UNITED STATES PATENT AND TRADEMARK OFFICE

APPLICATION NO.	FILING DATE	FIRST NAMED INVENTOR	ATTORNEY DOCKET NO.	CONFIRMATION NO.
10/534,180	05/05/2005	Bruno Herren	82000.2020	3374
20601 7590 02/23/2007 SPECKMAN LAW GROUP PLLC 1201 THIRD AVENUE, SUITE 330 SEATTLE, WA 98101			EXAMINER FRANCIS, FAYE	
			ART UNIT	PAPER NUMBER
			3725	
SHORTENED STATUTORY PERIOD OF RESPONSE		MAIL DATE	DELIVERY MODE	
3 MONTHS		02/23/2007	PAPER

Office Action Summary

DETAILED ACTION

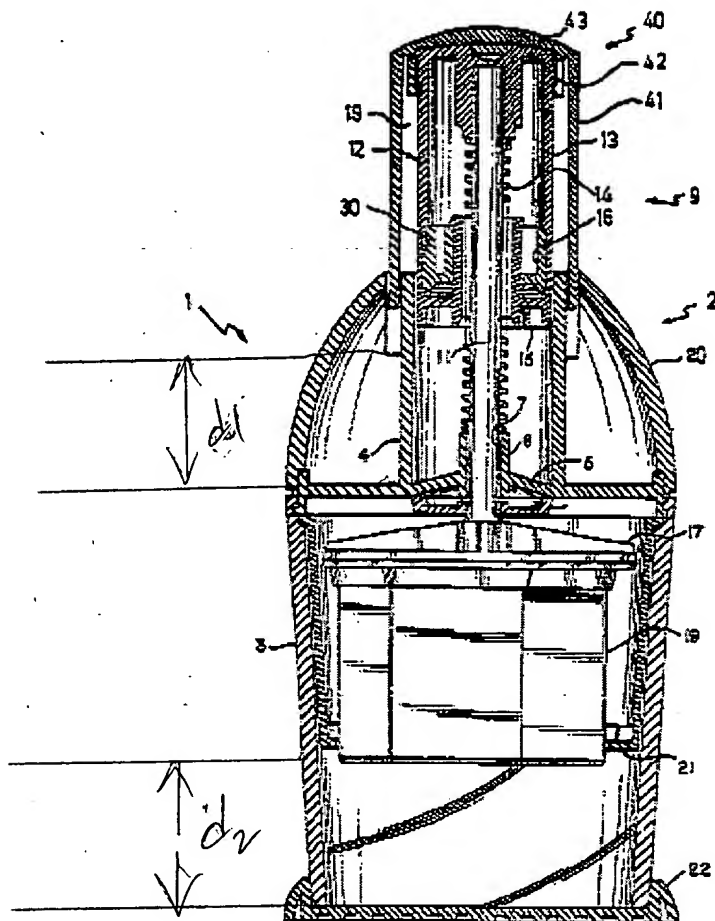
Treiss discloses in Fig 1 (also see Figure below wherein the letters d1 and d2 have been added by the examiner), a hand-operated crusher for cutting up ice, comprising a housing having an upper part [cap 10] and a lower part [container 11], a vertical rod [shaft 23], a spring 28, means of an actuating mechanism having a push button [knob 26] and a knife [blade 25] wherein the cutter at is lowermost position, does not contact the base of the housing lower part [Fig 1].

Michel discloses in Fig 1, a hand-operated crusher which is capable of cutting up ice, comprising a housing 1 having an upper part 2 and a lower part 3, a vertical rod [plunger 11], a spring 14, means of an actuating mechanism having a push button 12 and a knife 19 wherein the cutter at is lowermost position, does not contact the base of the housing lower part [d1 is less than d2].
